Design Review
Recommendation
Meeting
February 6, 2008

506 Belmont Avenue E
Seattle, Washington

DPD Project #3006603

Arca Architecture
91 Marion Street
Seattle, WA 98104

EDG #2

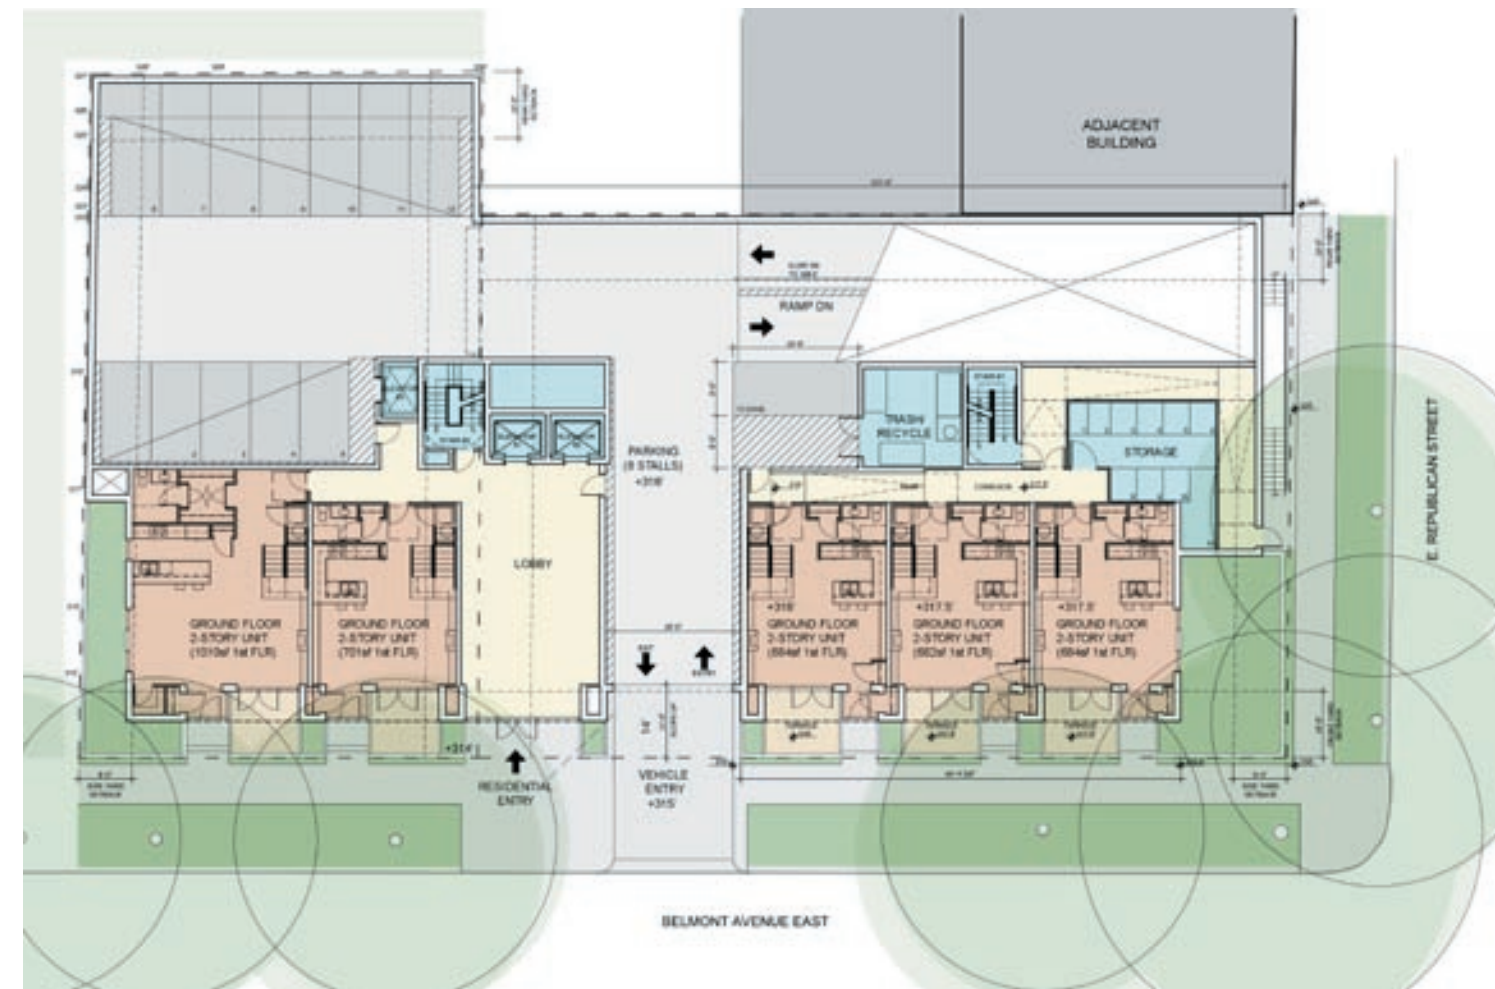
The Board, concerned about the survivability of the existing street trees, asked to see an assessment of the health and risk from construction to the trees at the Recommendation meeting.

The Board supports the concept of ground-related units with connection to the street on Belmont Avenue East and noted that the applicant has made a similar connection from the units on East Republican recommended at the first EDG meeting. The Board also noted that there appears to be lower and more transparent privacy screening for these units than previously shown.

The Board is not wholly convinced that the side-by-side lobby and vehicle entrance is the best solution and is concerned about potential car/pedestrian conflicts.

The Board would like to see a more prominent lobby entrance. The lobby should be more fully glazed.

The Board feels the terraced open space area at the corner of Belmont E and Republican appears unusable. The applicant should provide a portion of this space as a respite for pedestrians. The balance should be for use by the adjacent ground-related units.

The Board is supportive of the building depth departure request for the south and east edge of the building as a means to ameliorate the blank wall of the existing building to the east on Republican. The Board questioned the apparent proximity of the lower level units to the carport structure which is accessory to the building located to the east on Republican.

The Board wish to see reduced impact on Tashkent Park.

The Board agreed that the base treatment was a positive feature and requested that it extend around the south end to form a complete base.

The Board suggested that the vehicular entrance be recessed as much as possible so that it is visually minimized. The Board applauded the reduction of the width of vehicle entrance on Belmont Avenue East.

The Board was pleased to see that the applicant had introduced upper level windows into the end ground-related unit on the south which provides relief to an otherwise blank wall and also affords views to the southwest.
